Access Compliance Report Public Rights-of-Way (Curb Ramps)

Intersection ID: 49248	Main Street: BOOMERANG_WY	Cross Street: PROSPERITY_VIEW_DR	Location: N
ADA ID: 4EC0DA9C8F21	Ramp Type: PerpDiag	Initial Pass/Fail: Fail	Overall Compliance: No Severity Score: 10

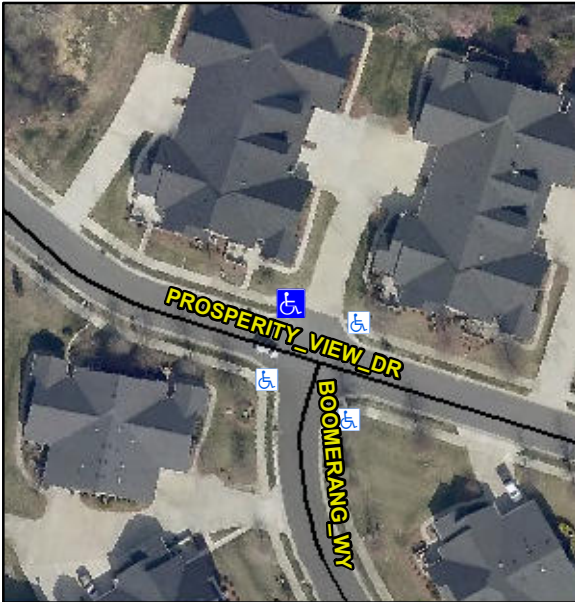
Not Found, R304.5.1, R304.5.3

Compliance	Description	Data	Compliance	Description	Data
N/A	Ramp Length (in)	48.0	Yes	Ramp Slope (%)	5.5
No	Ramp Width (in)	47.0	No	Ramp XSlope (%)	2.4
N/A	Flare Type LT	N/A	N/A	Flare Type RT	N/A
N/A	Flare Slope LT (%)	N/A	N/A	Flare Slope RT (%)	N/A
N/A	Flare Traversable LT?	N/A	N/A	Flare Traversable RT?	N/A
N/A	Landing Length (in)	N/A	N/A	DWS Provided?	N/A
N/A	Landing Width (in)	N/A	N/A	DWS Contrast?	N/A
N/A	Landing Slope (%)	N/A	N/A	DWS Length (in)	N/A
N/A	Landing X Slope (%)	N/A	N/A	DWS Full Width?	N/A
N/A	Landing Curb? (Y/N)	N/A	N/A	DWS Offset (in)	N/A
N/A	Shared Landing?	N/A			
N/A	Gutter Ponding?	N/A	N/A	Gutter Slope (%)	N/A
N/A	Gutter Lip Ht (in)	N/A	N/A	Gutter X Slope (%)	N/A
N/A	Painted X Walk1?	No	N/A	Painted X Walk2?	No
	X Walk 1 Direction	To SW		X Walk 2 Direction	To SE
N/A	X Walk 1 Width (in)	N/A	N/A	X Walk 2 Width (in)	N/A
	X Walk 1 Slope (%)	7.3		X Walk 2 Slope (%)	4.1
	X Walk 1 X Slope (%)	1.3		X Walk 2 X Slope (%)	1.2

N/A	Ramp inside XWalk1?	N/A	N/A	Ramp inside XWalk2?	N/A
	Road Slope (%)	1.5	N/A	Clear Space?	N/A
	Road X Slope (%)	3.8	N/A	Clear Space to XWalk (in)	N/A
N/A	Any Obstructions?	N/A	N/A	Storm Grate/Utility Hazard?	N/A
	Obstruction Type			Storm Grate/Utility Type	
		N/A			N/A
			Yes	Surface Condition? (G/P)	Good

Possible Solutions:
Remove & Replace Curb Ramp With Two New Directional Ramps or Equivalent.
